MANUAL CHANGES

RF SECTION 1- 2600 MHz

Model Number: 86603A
Date Printed: June 1980
Part Number: 86603-90023

Change 2. P/O Figure 8-12. A7 Mixer Section Schematic Diagram

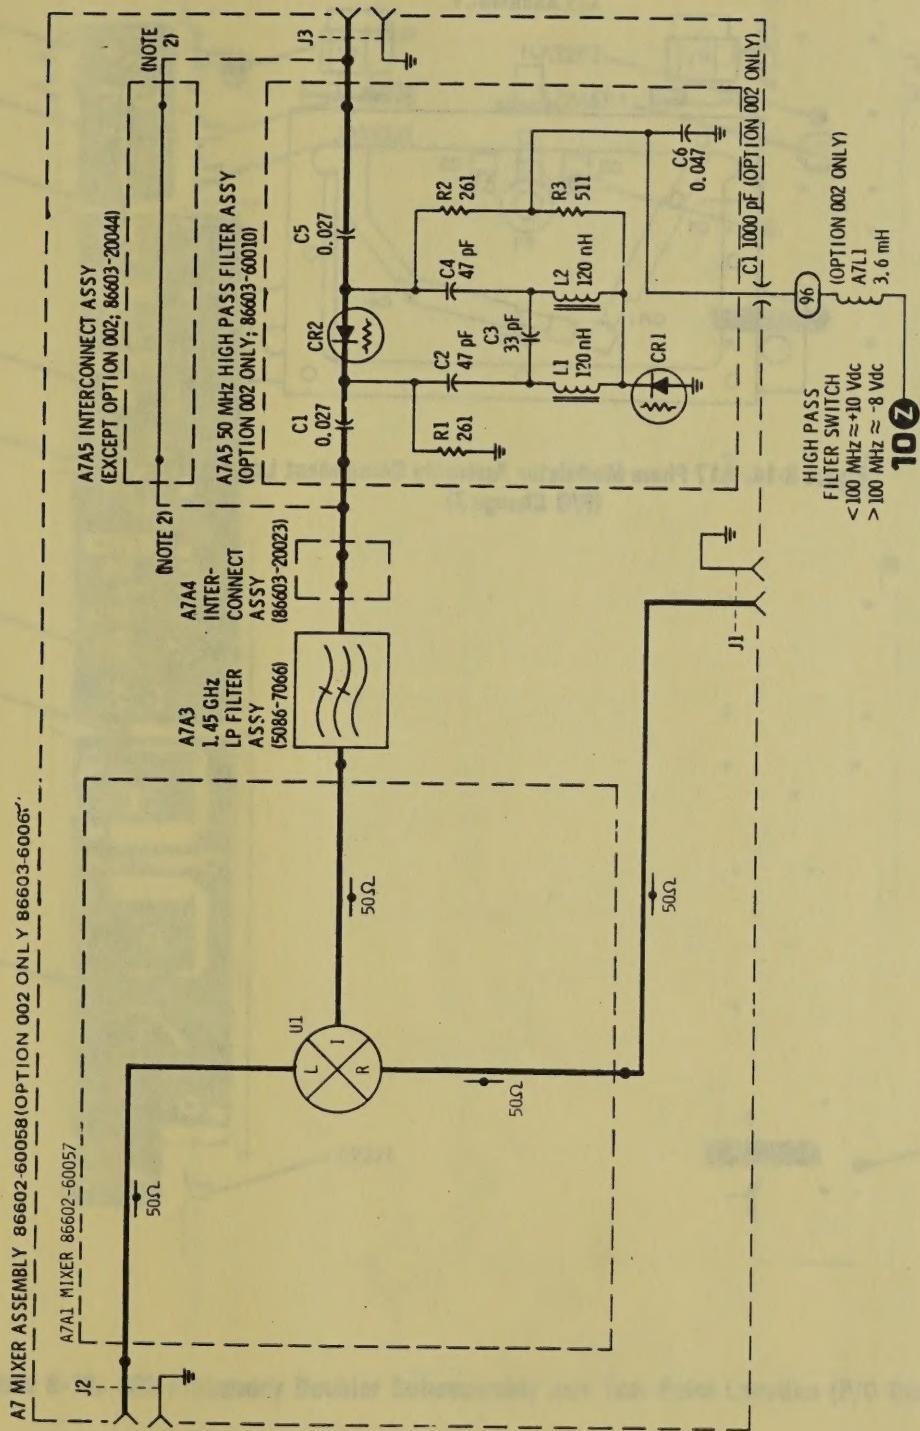
Page 8-27, Figure 8-12 (Service Sheet 4):

Change A7 title to read: A7 MIXER ASSEMBLY 86602-60058; (OPTION 002 ONLY
86603-60060).

Delete A7A2 and A7A2CR1 from the Table of Reference Designations.

Replace A7A1 portion of schematic with partial schematic in this
supplement.

**Figure 8-14. A17 Phase Modulator Assembly Component Locations
(P/O Change 3)**

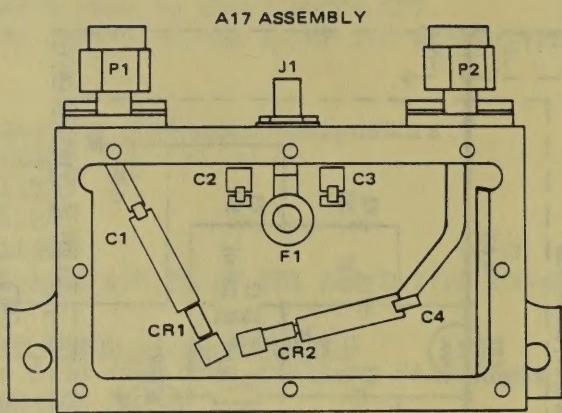
Page 8-29, Figure 8-14 (Service Sheet 5):

Replace Figure 8-14 with figure from this supplement.

Figure 8-18. A22 Frequency Doubler Subassembly and Test Point Location (P/O Change 5)

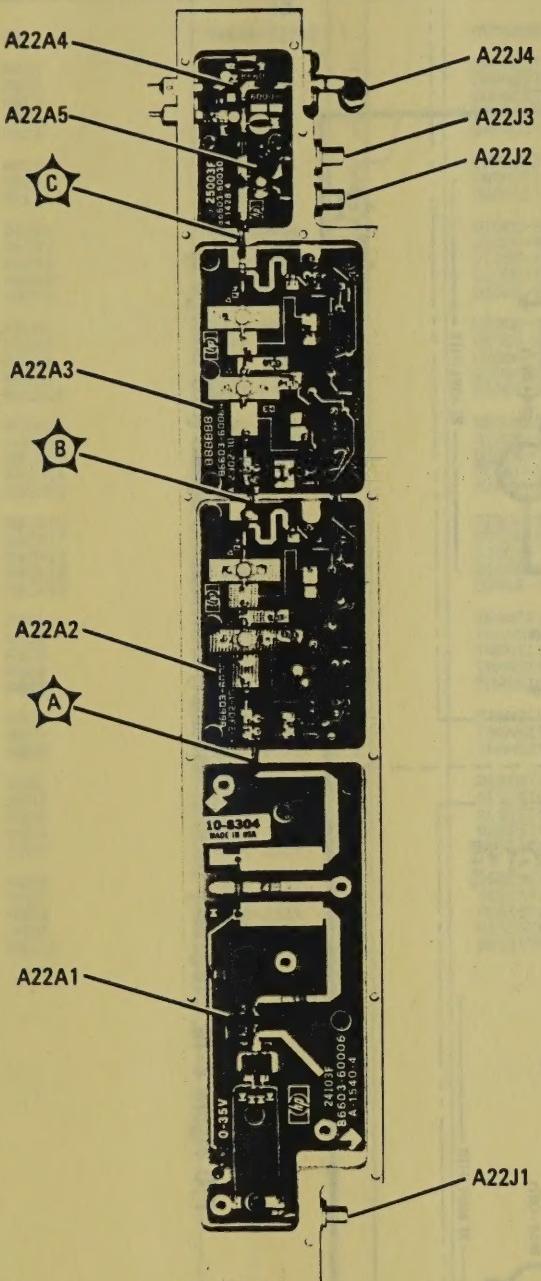
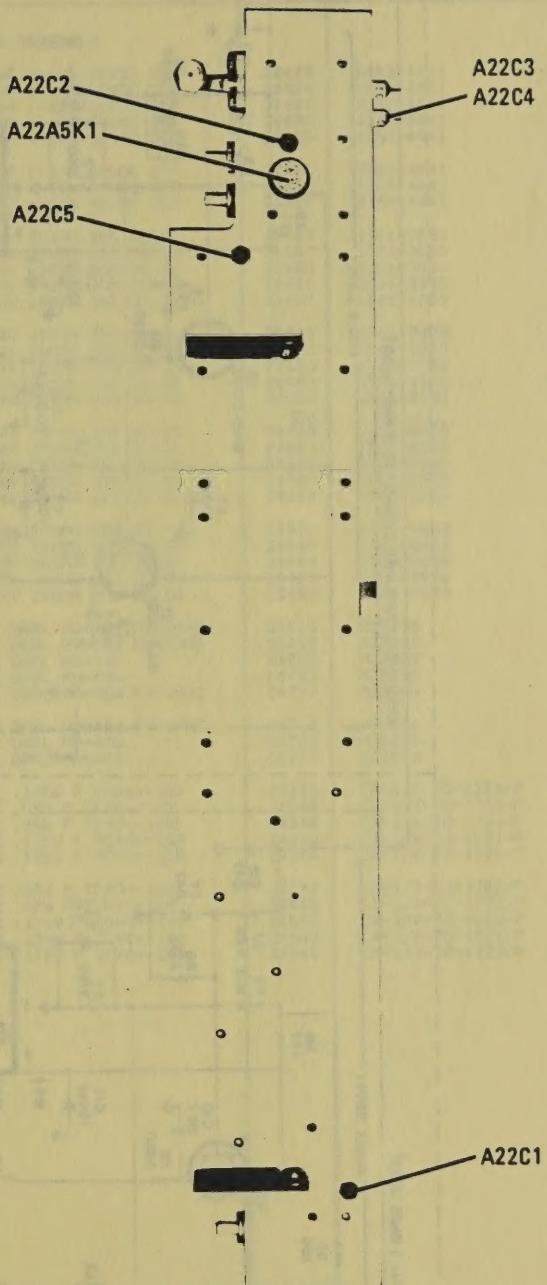
Page 8-33, Service Sheet 7 (Component Locations):

Replace Figure 8-18 with figure from this supplement.

P/O Figure 8-19. Frequency Doubler Assembly Schematic Diagram (P/O Change 5)

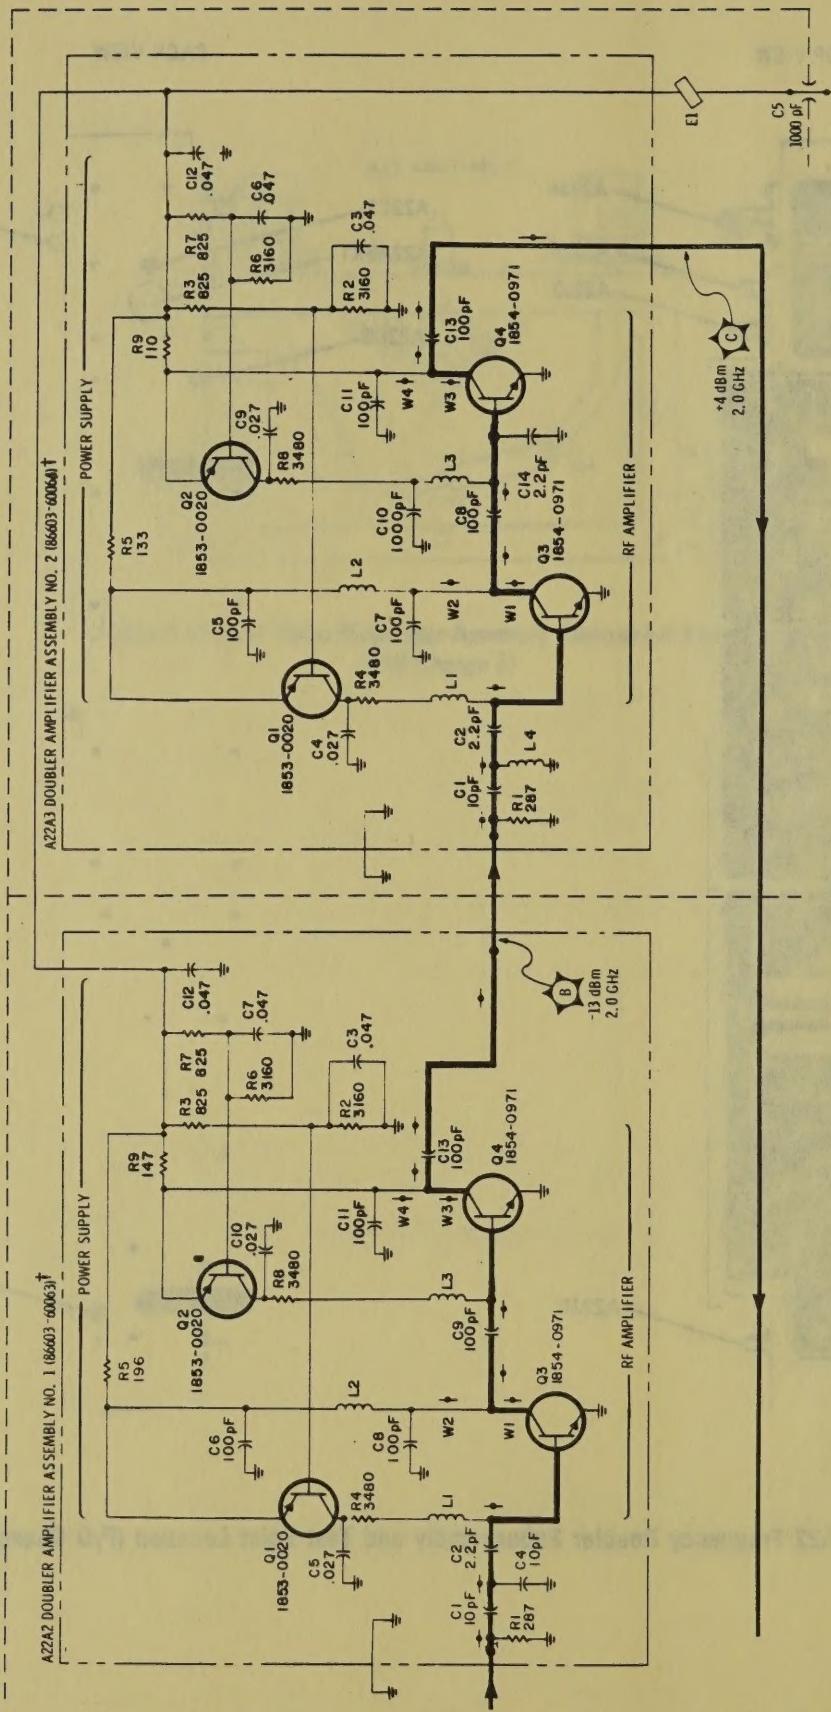
Page 8-33, Service Sheet 7 (Schematic):

Replace schematics for A22A2 and A22A3 with schematics from this supplement.

Change A22 Assembly Part Number on upper left corner of the schematic to 86603-60061.

Figure 8-24. A9 Attenuator Driver Assembly Component Locations

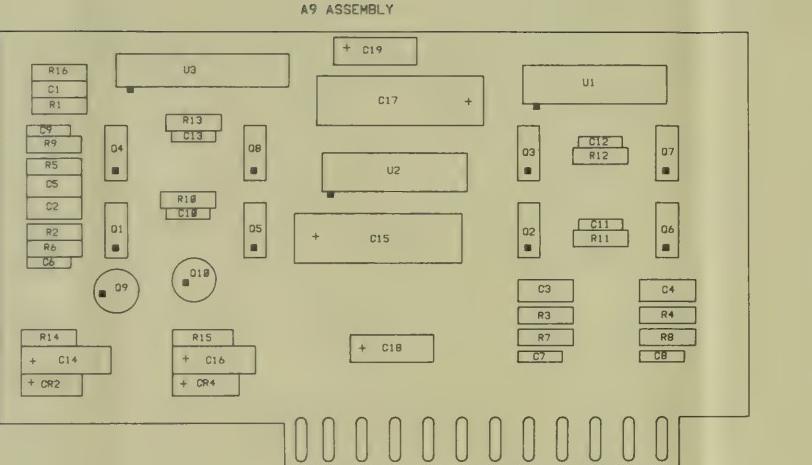
Replace Figure 8-24 with the attached A9 Assembly component locations diagram.

Fig. 8-25. Attenuator
Schematic Diagram

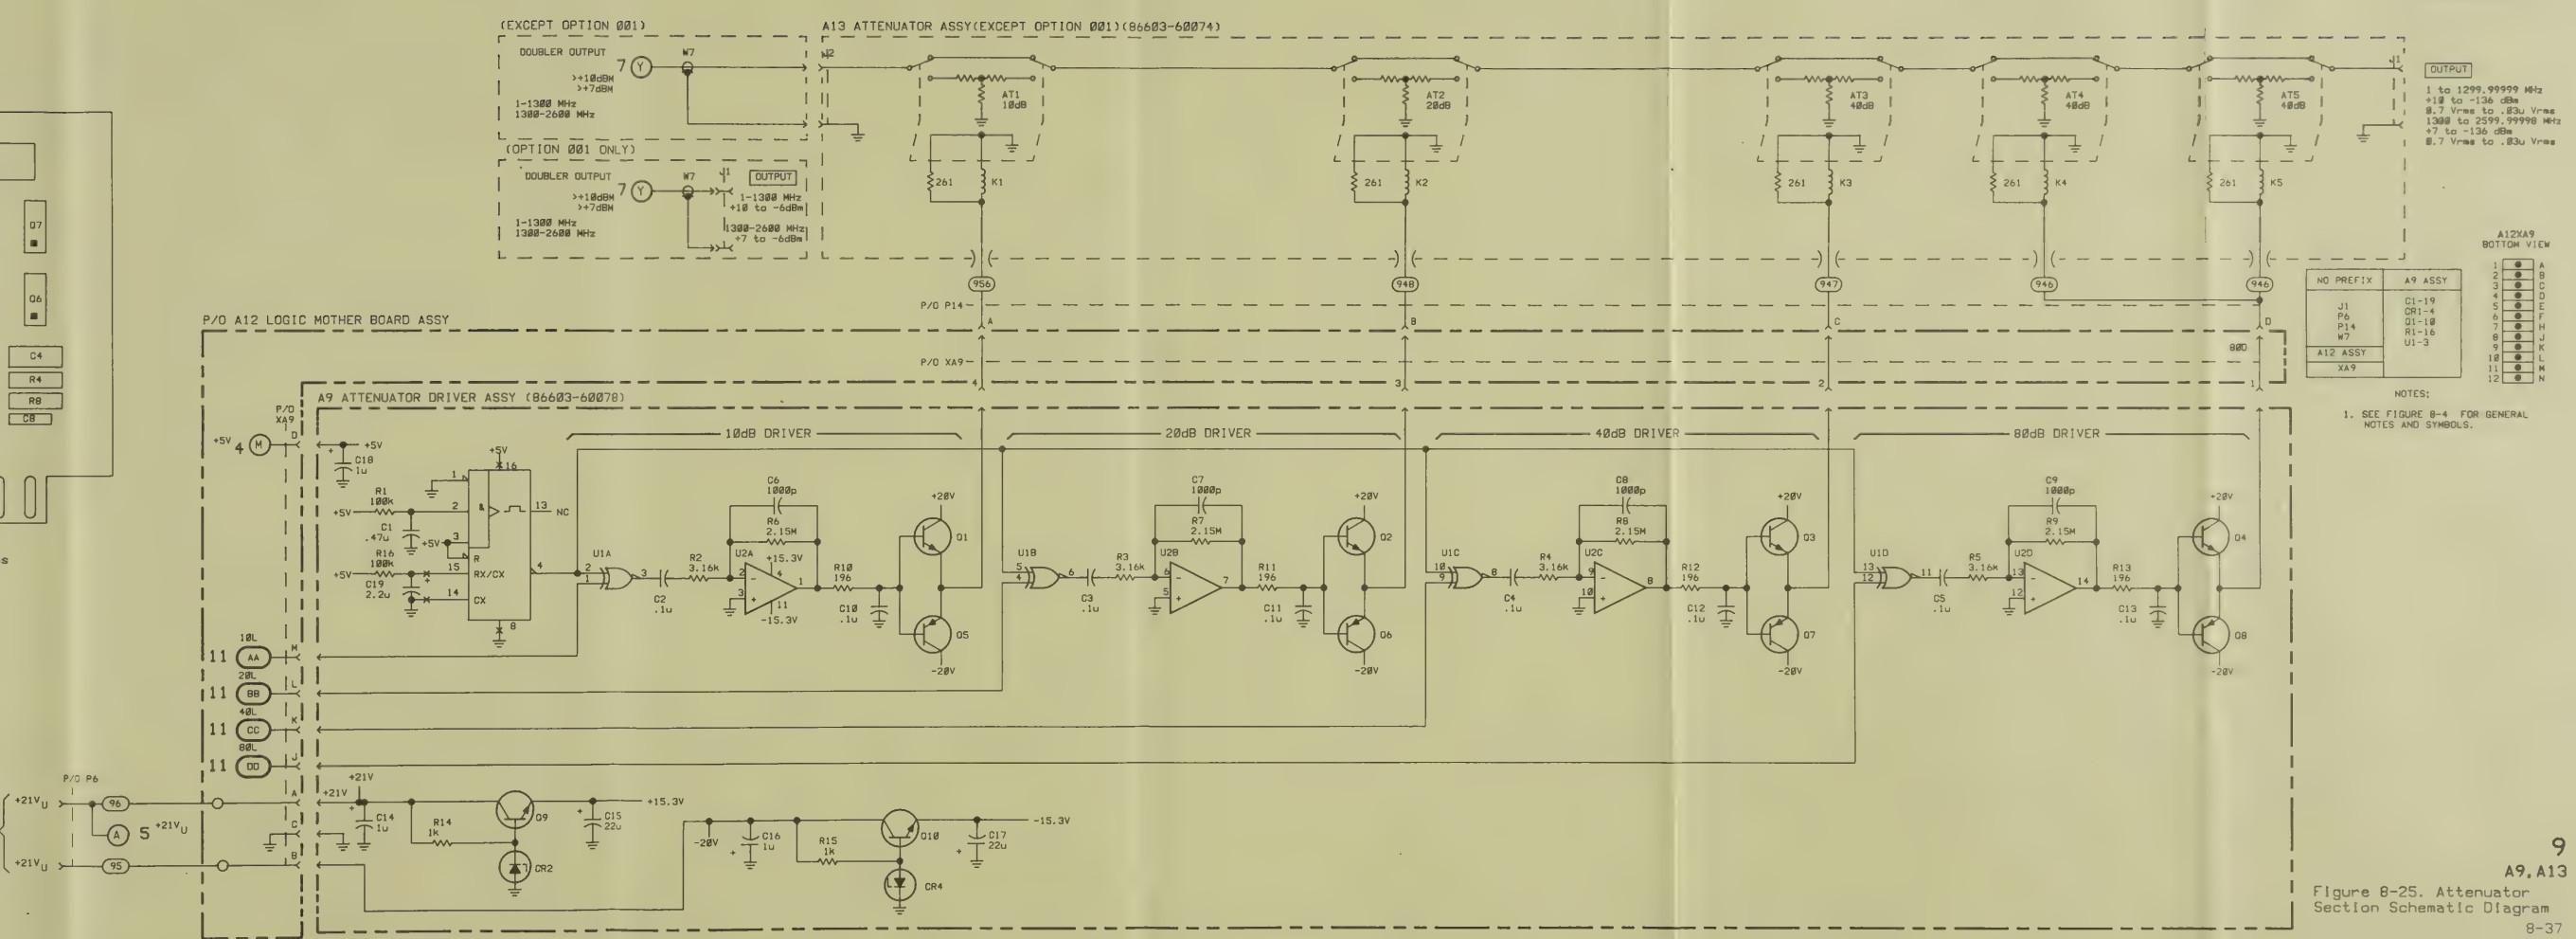
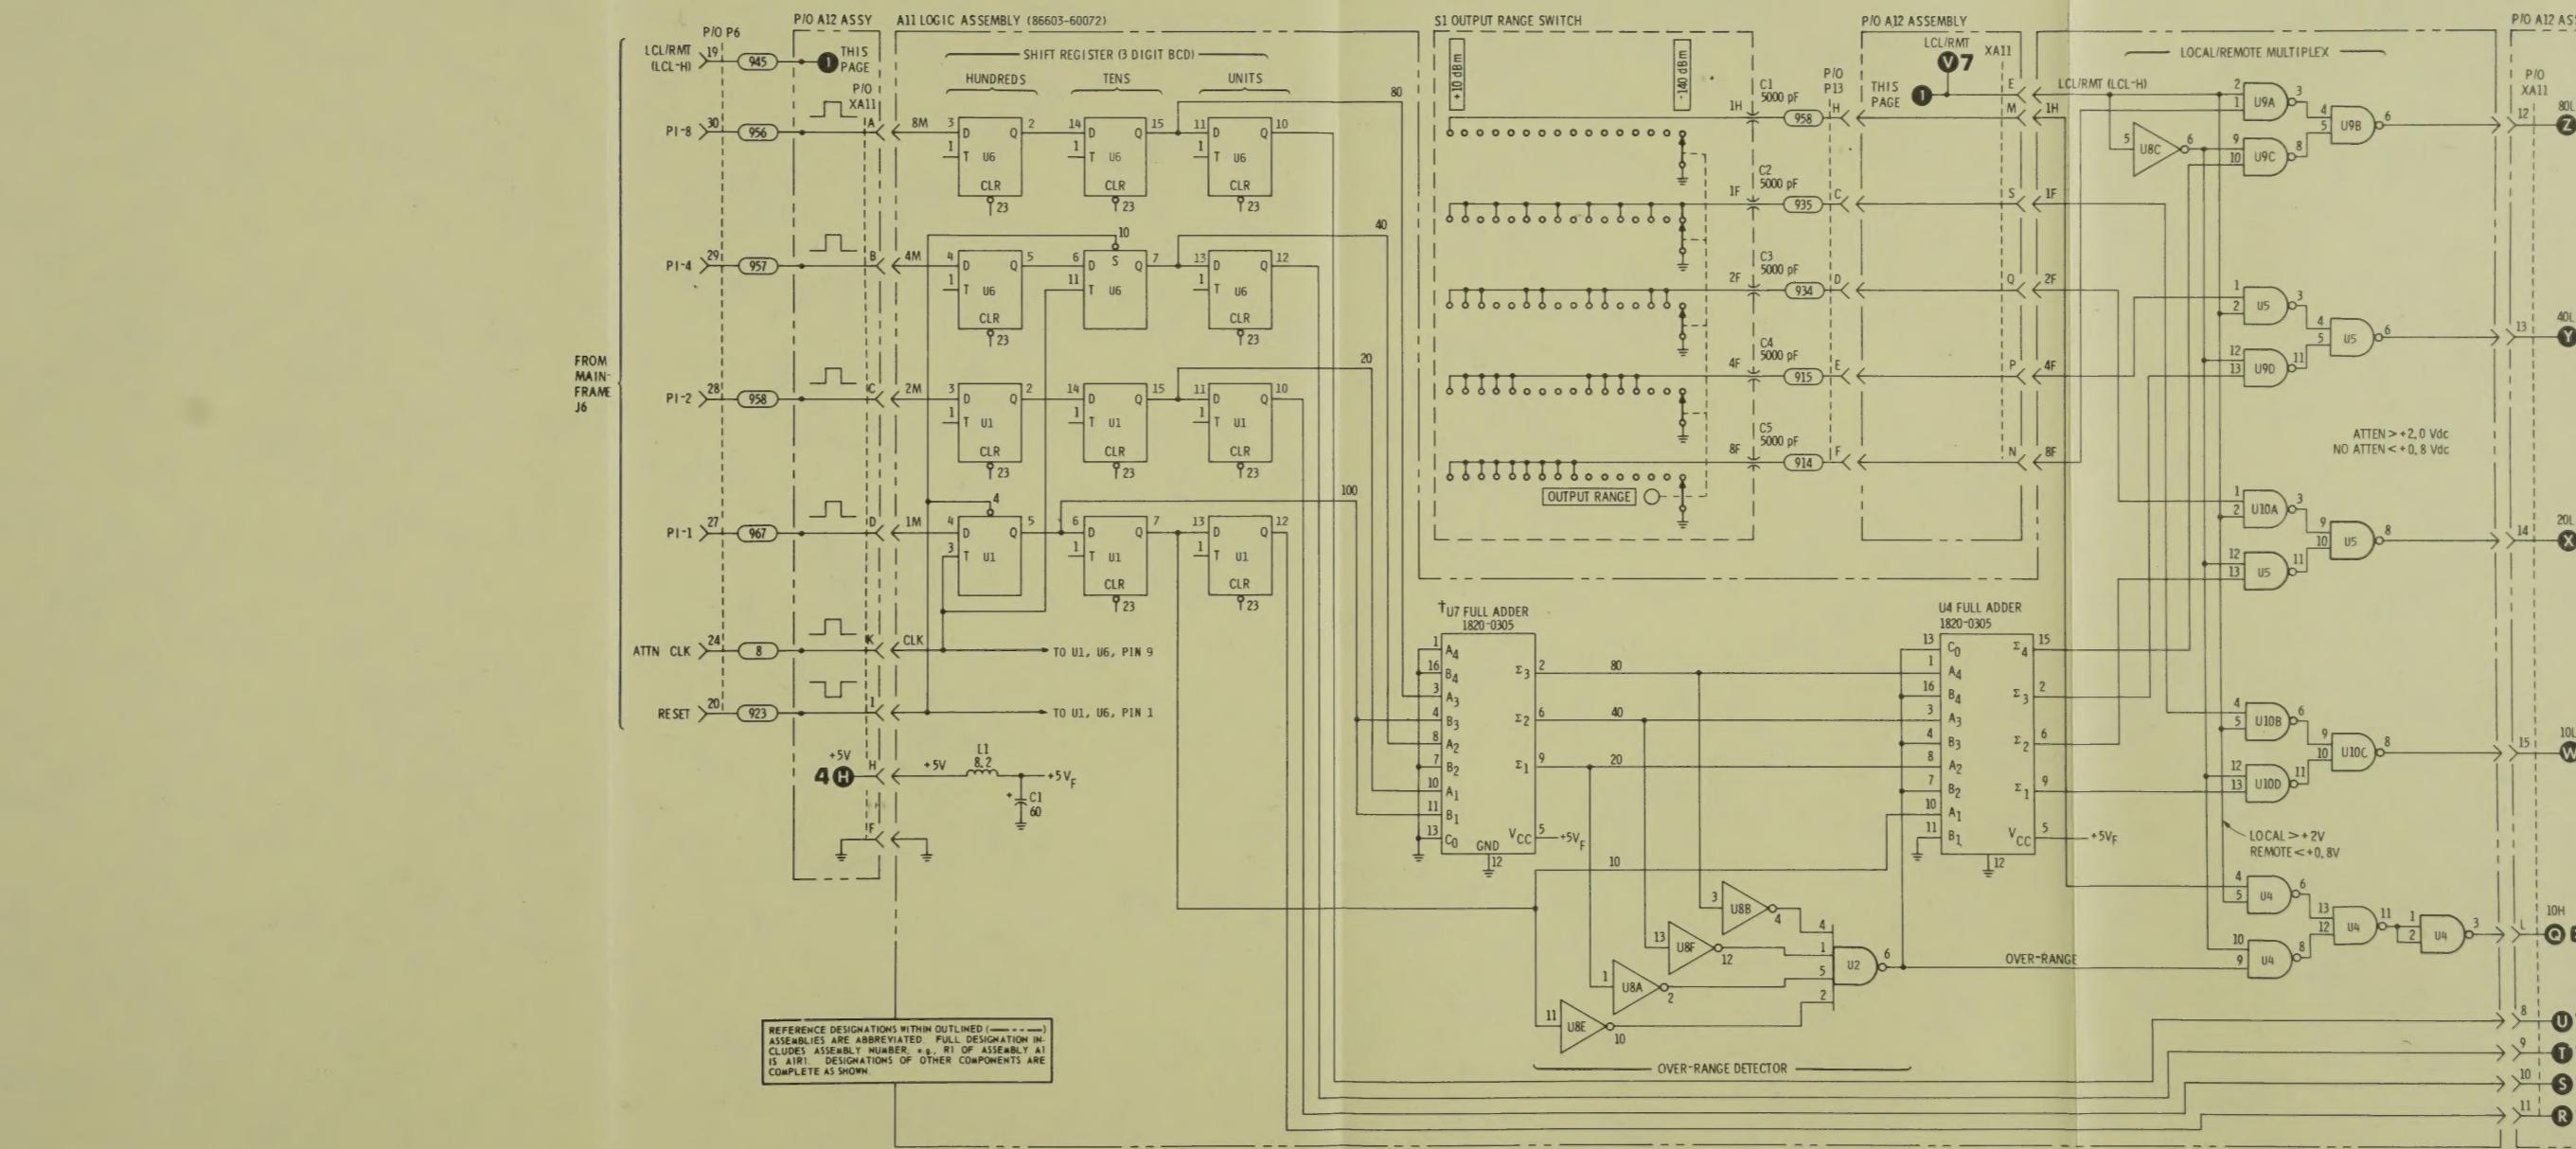
Page 8-37, Service Sheet 9:

Replace the A9 Assembly portion of Figure 8-25 with the attached "P/O Figure 8-25. (P/O CHANGE 8)".

Replace the entire Service Sheet 9 with the attached, "Service Sheet 9". (P/O CHANGE 9).
